**ADDENDUM NO. 1
TO CONTRACT NO. 3071V
GLEN CANYON PARK IMPROVEMENTS**

**ADDENDUM NO. 1
TO CONTRACT NO. 3071V DPW ID NO FCP12096)
GLEN CANYON PARK IMPROVEMENTS
July 3, 2012**

SK-L-0.1

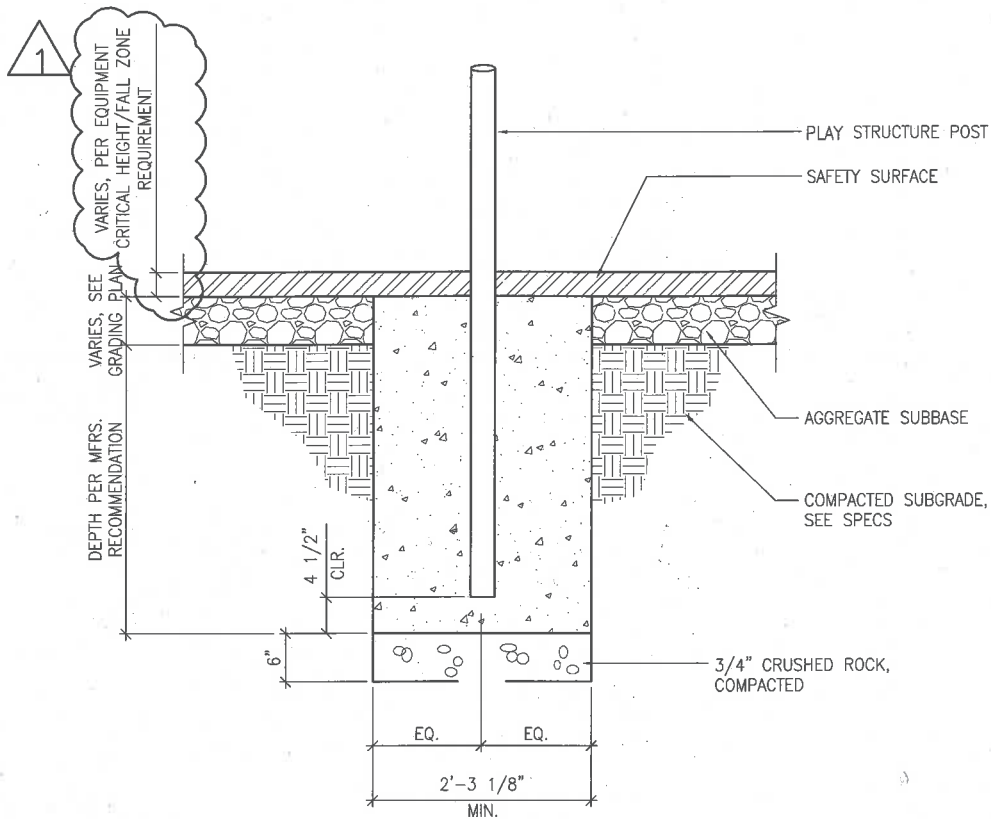
<i>Sketch No.</i>	<i>Revising Drawing No.</i>	<i>Comments</i>
SK-L-0.1	L-8.0	Revised Detail No. 4
SK-L-0.2	L-8.9	Revised Detail No. 5
SK-L-0.3	L-8.12	Revised Detail No. 4
SK-L-0.4	NEW	Reference photos of existing playground equipment to be removed.

PIP SAFETY SURFACE

SK-L-0.2

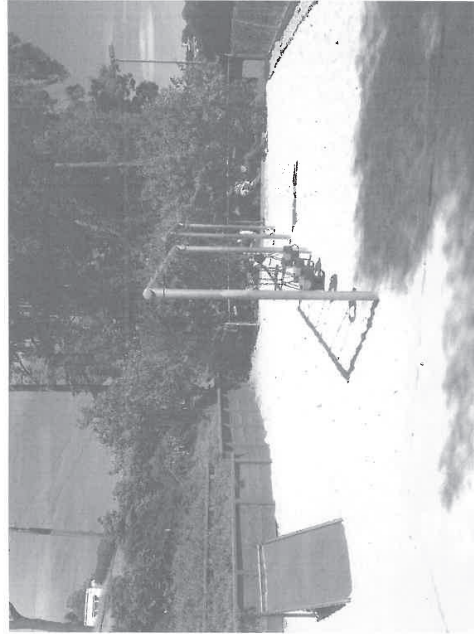
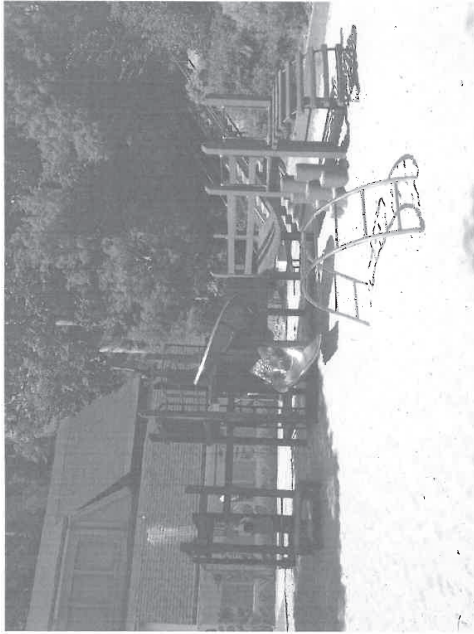
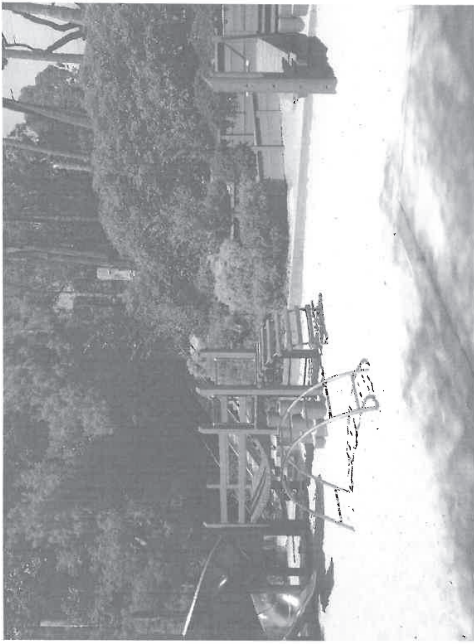
TYPICAL FOOTING FOR PLAY EQUIPMENT
